[Docket No. FAA–2009–0218; Directorate Identifier 2009–CE–006–AD]

Airworthiness Directives; Piper Aircraft, Inc. PA–23, PA–31, and PA–42 Airplanes

ACTION: Notice of proposed rulemaking (NPRM).

Figure 1. – Nose Baggage Door Placard.

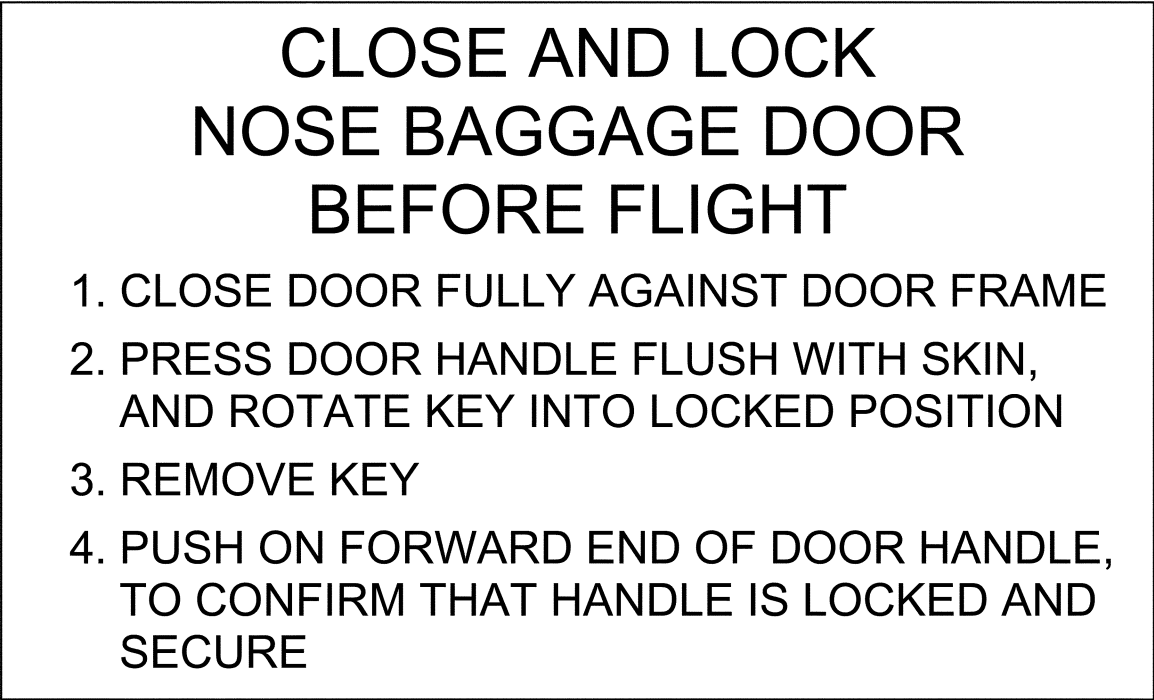
Actions	Compliance	Procedures
(1) For all aircraft: (i) Inspect the nose baggage door assembly for damaged, worn, corroded, or non-conforming components; (ii) Replace life-limited components specified in the service information; and (iii) Install or inspect, as applicable, the nose baggage placard following the service information.	Initially within 1,000 hours time-in-service (TIS) since all life-limited components were installed new following Piper Aircraft, Inc. Mandatory Service Bulletin No. 1194A, dated November 10, 2008, or within the next 100 hours TIS after July 24, 2009 (the effective date retained from AD 2009–13–06), whichever occurs later. Repetitively thereafter at intervals not to exceed 1,000 hours TIS.	Follow INSTRUCTIONS: PART I of Piper Aircraft, Inc. Mandatory Service Bulletin No. 1194A, dated November 10, 2008. As an alternative to using part number 100700–079 placard, you may fabricate a placard (using at least 1/8-inch letters) with the words in figure 1 of this AD and install the placard directly above the nose baggage door handle. This AD does not require verification of proper functioning of the nose baggage compartment interior light as stated in the last sentence of PART 1, paragraph 1, of Piper Aircraft, Inc. Mandatory Service Bulletin No. 1194A, dated November 10, 2008.
